ADDENDUM NO. ONE (1)
CITY OF SPARTA, GEORGIA
SPARTA SEWER SYSTEM REHABILITATION
CONTRACT 1 – PUMP STATION REPLACEMENTS
ISSUED OCTOBER 27, 2025

EMI PROJECT No. 23-021

This Addendum forms a part of the Contract Documents and Drawings, and modifies the original bidding documents dated October 2025.

E1

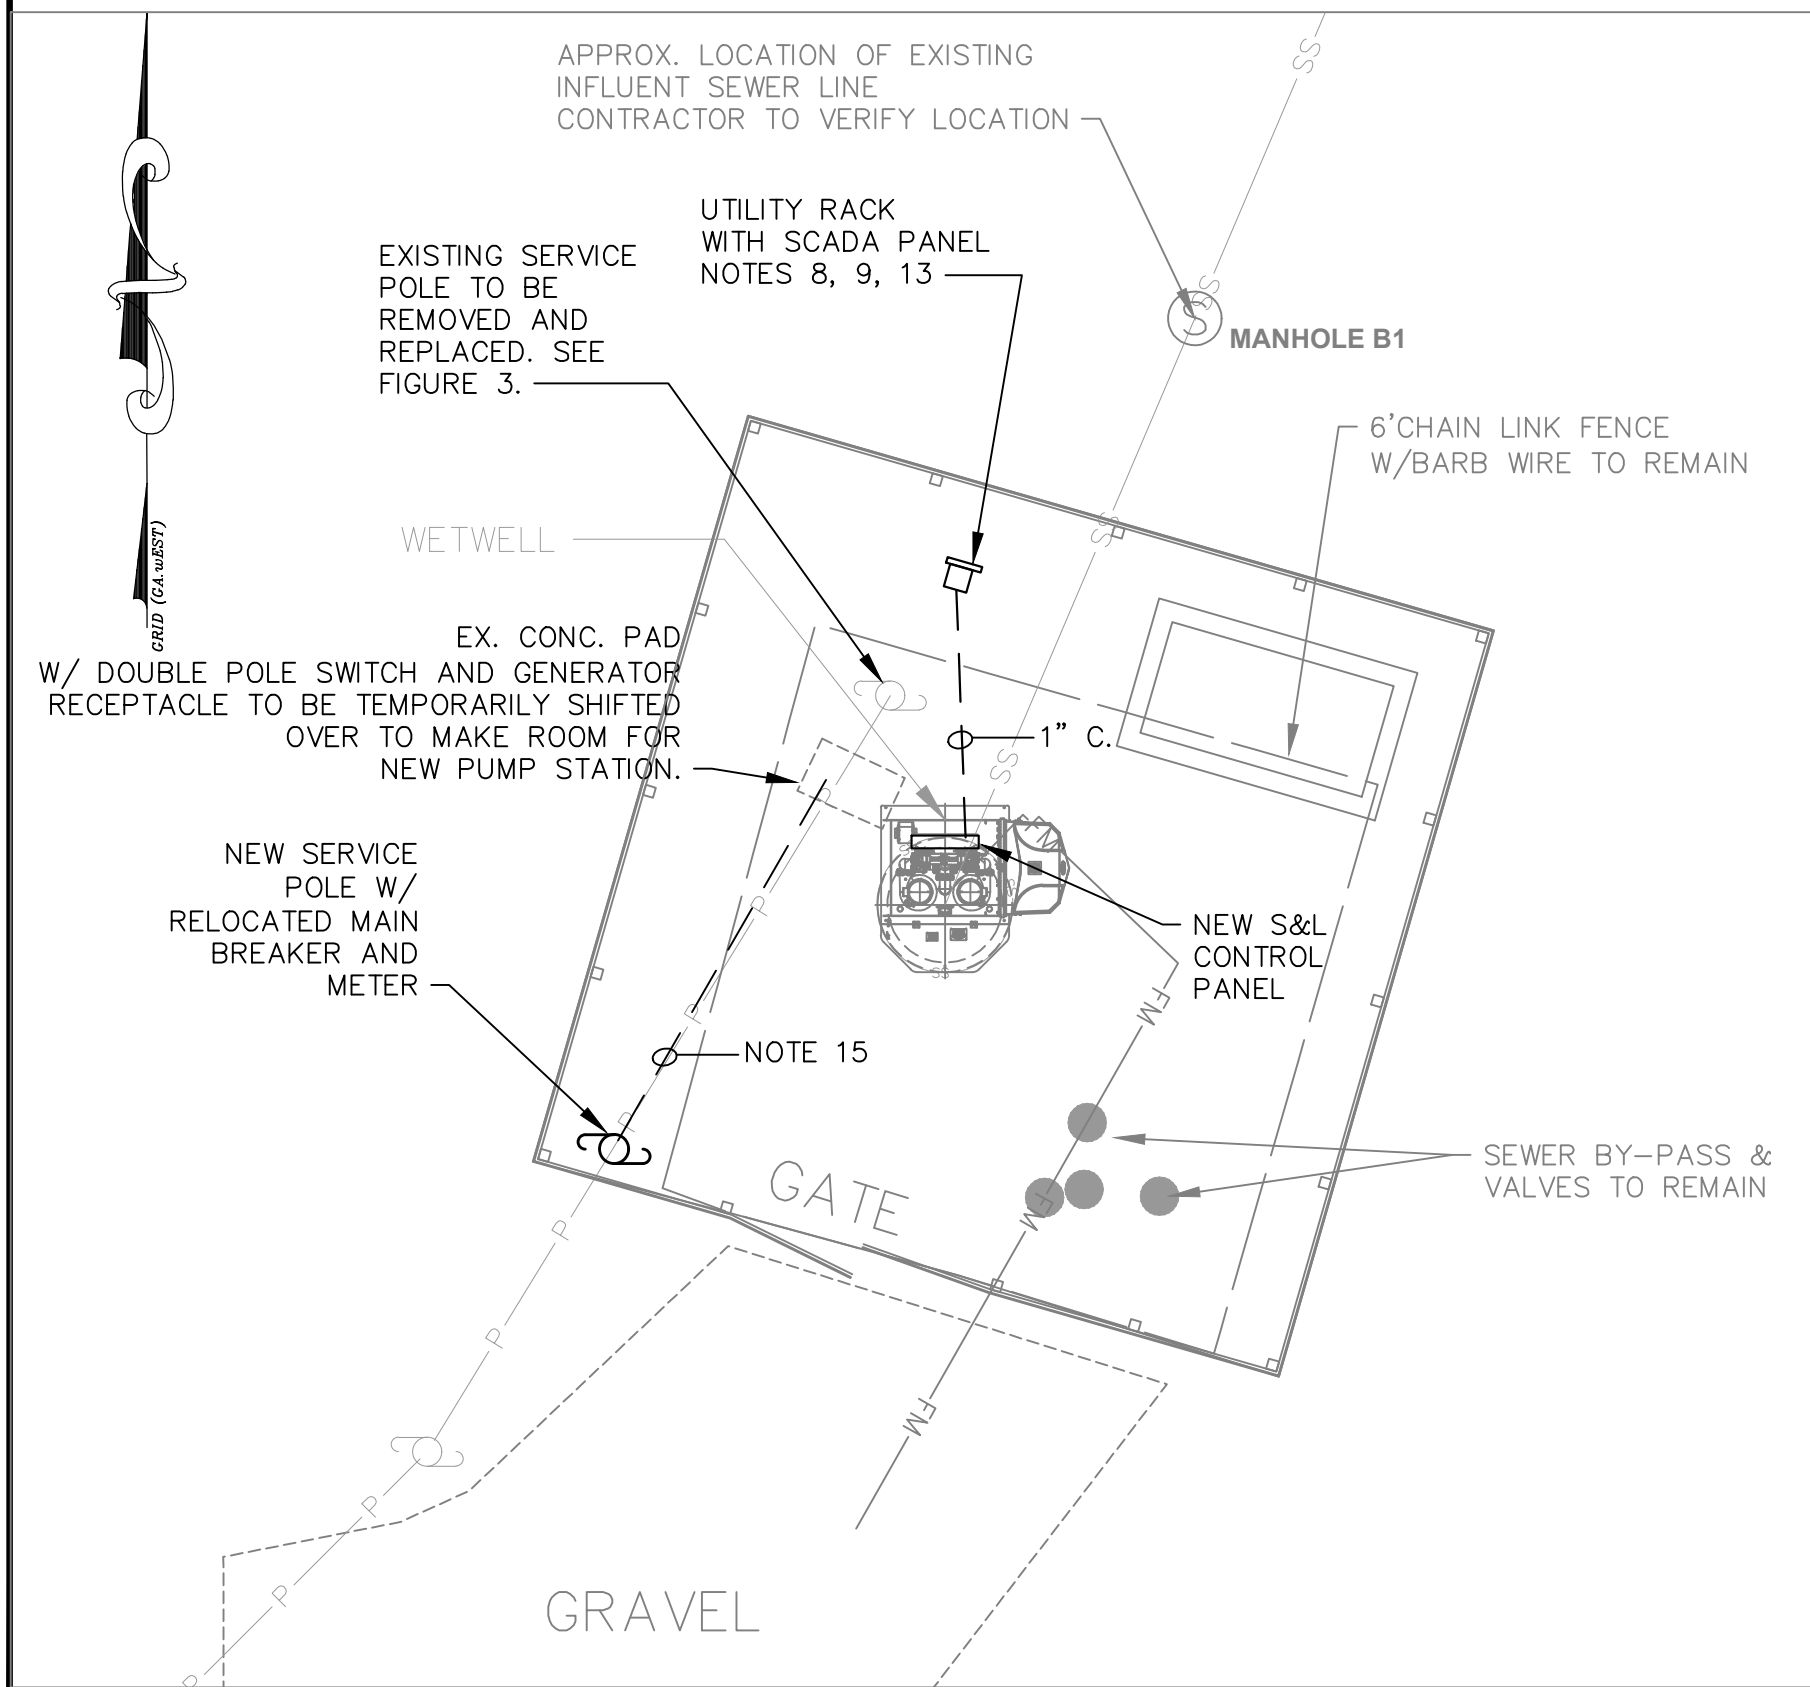
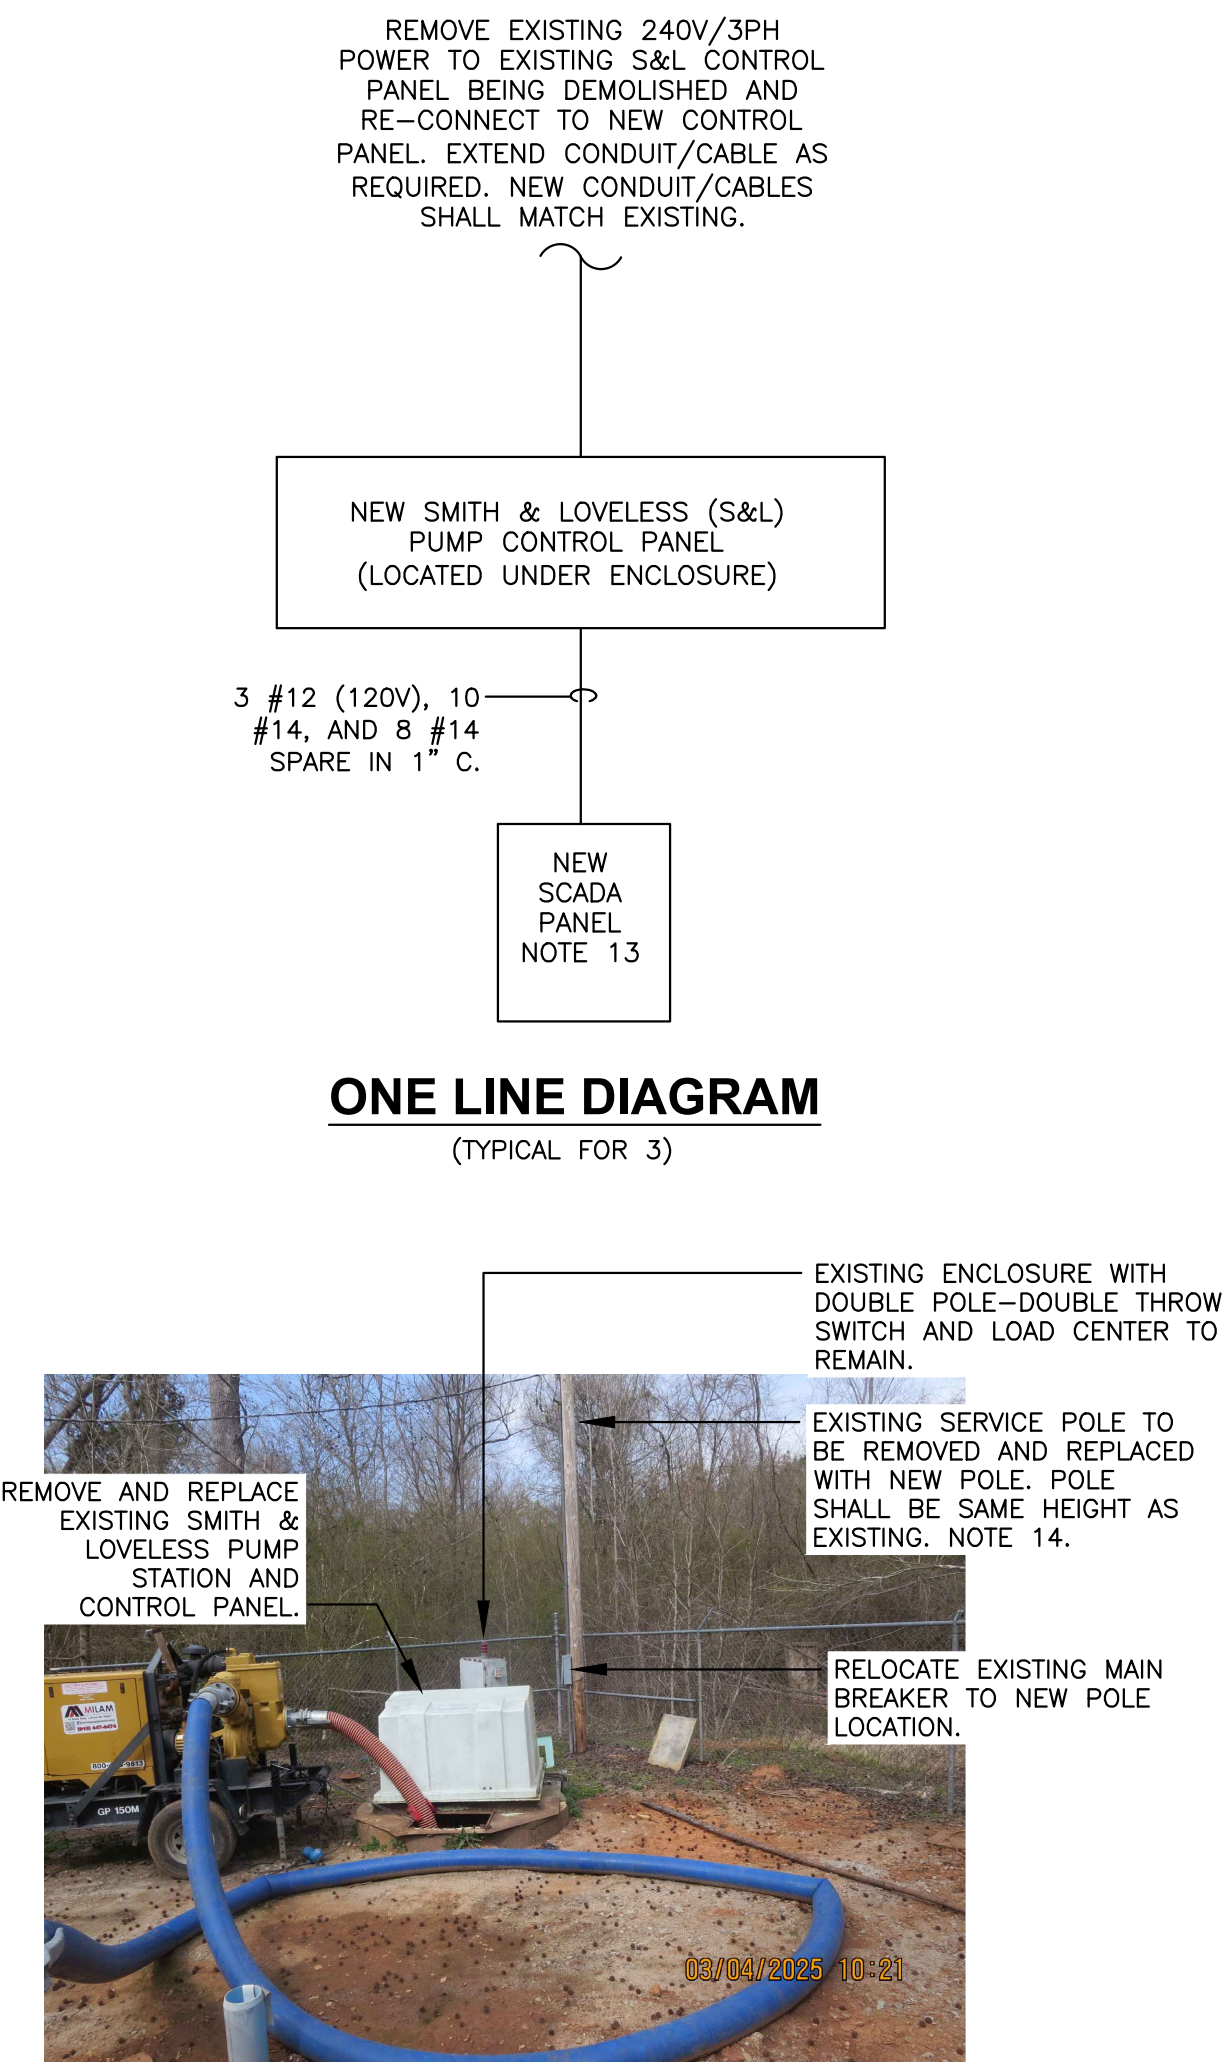
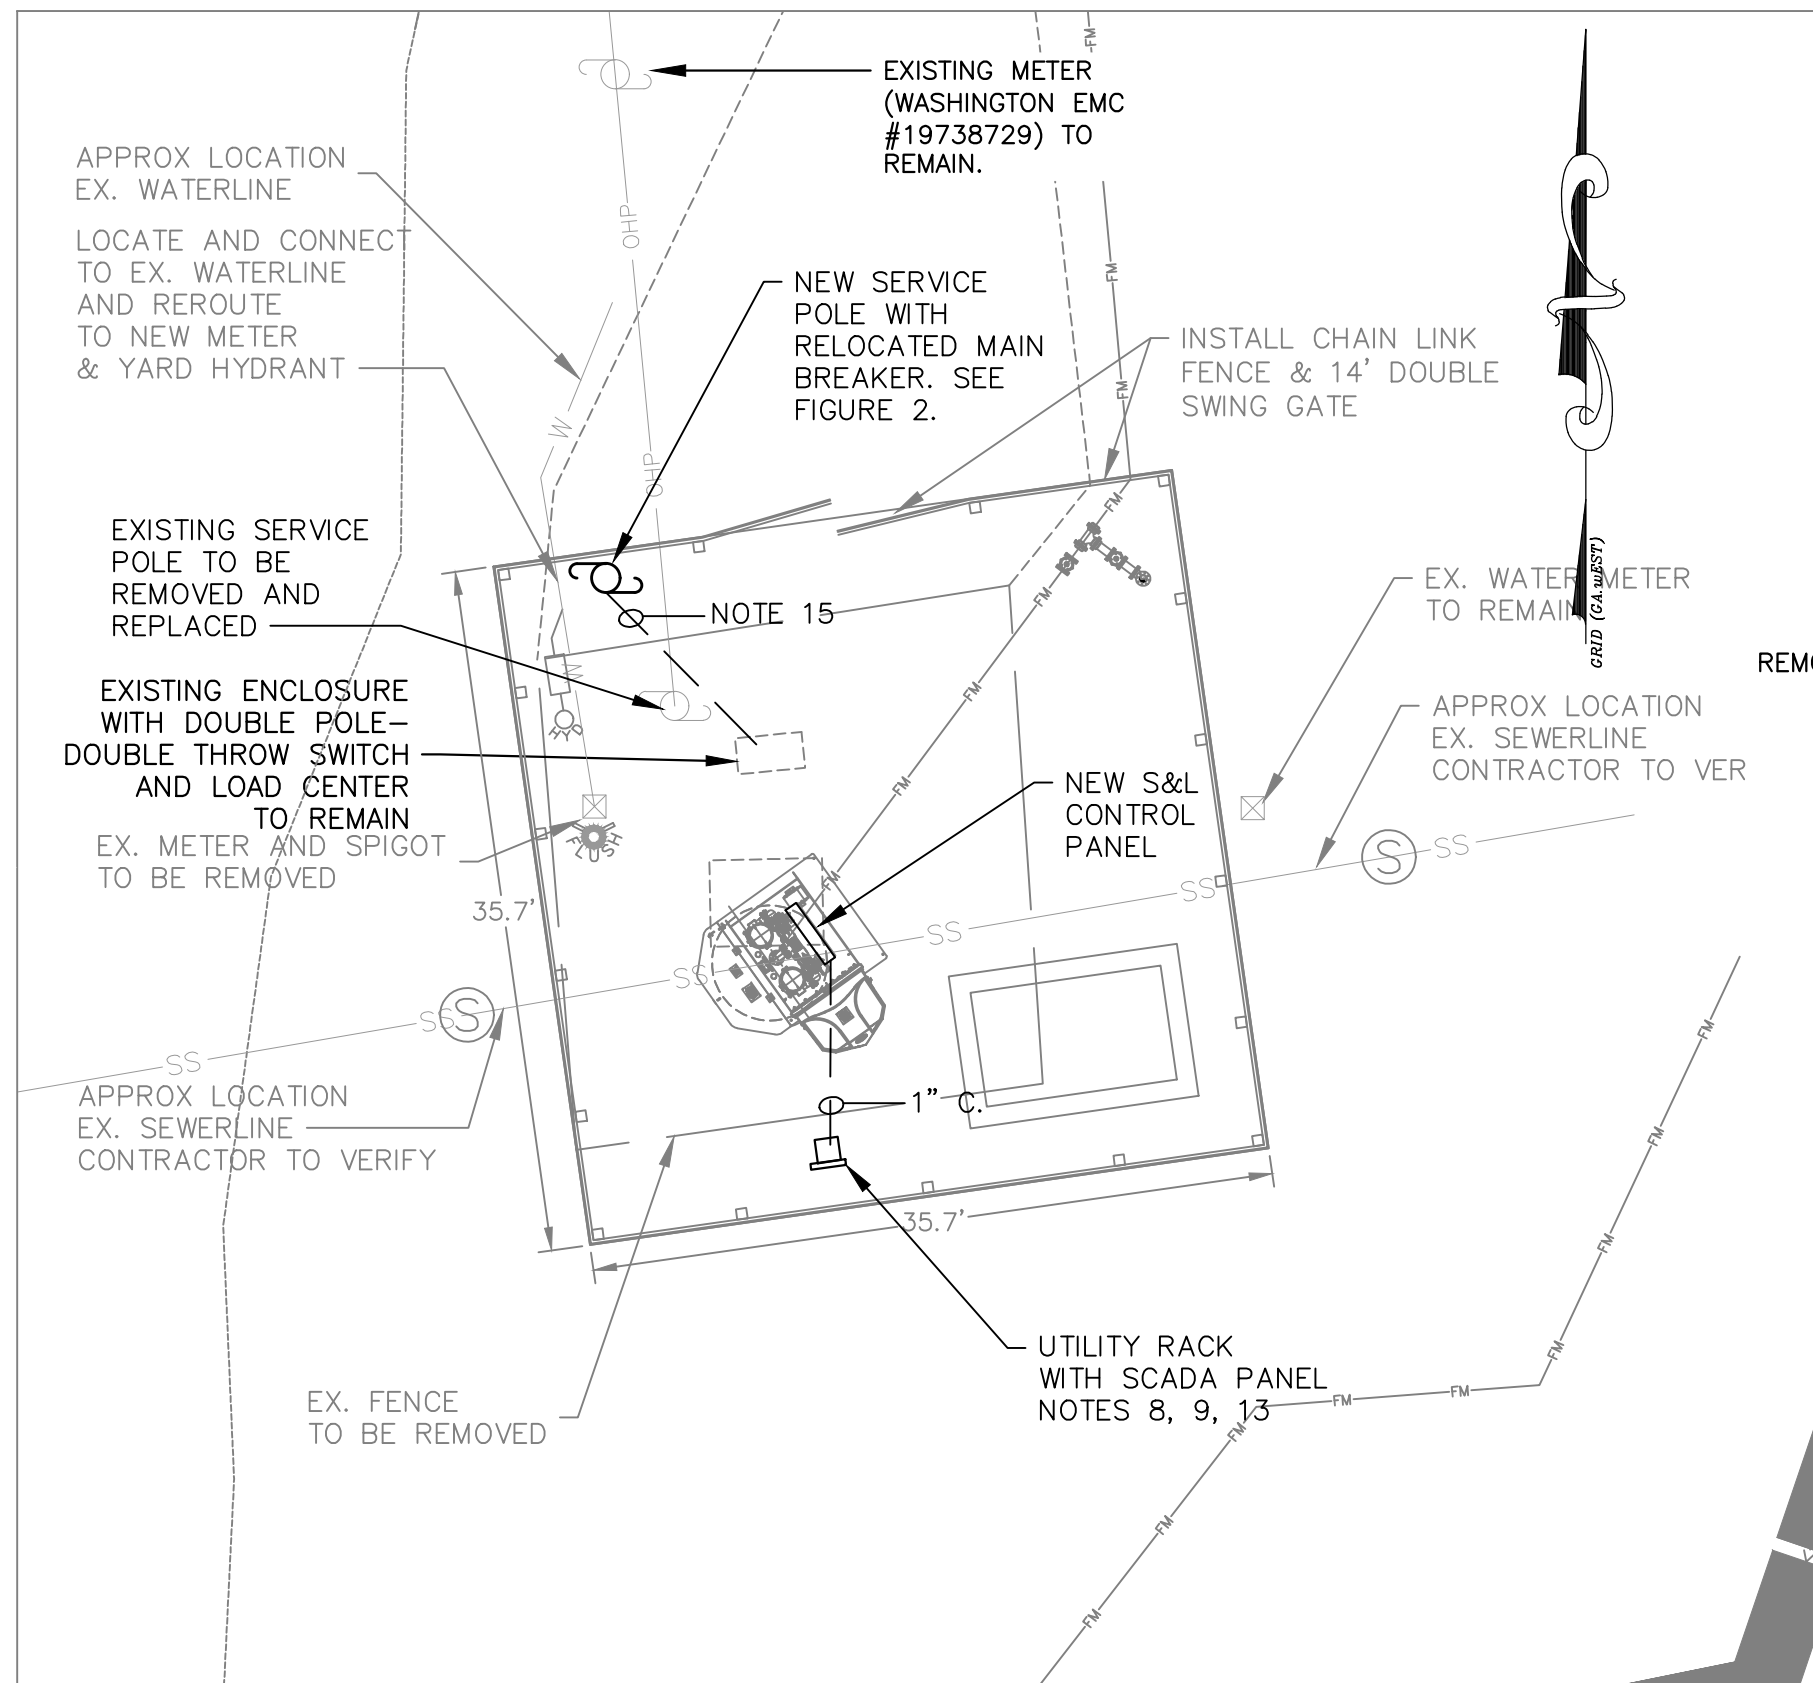
The following electrical plan sheets have been added to the project plans.

- **E1: Sparta Pump Stations Electrical Site Plans, Notes, and Details**
